Farkantex Limited (10515)

17.MAY.2014

ACCORD
on Fire and Building Safety in Bangladesh

1st Priority 3 Concern

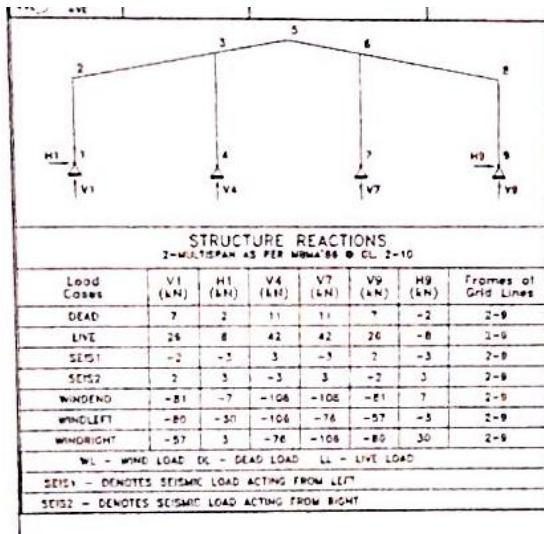
No fire proofing material is applied to the Structural steel elements. It is unclear whether this would be required by BNBC.
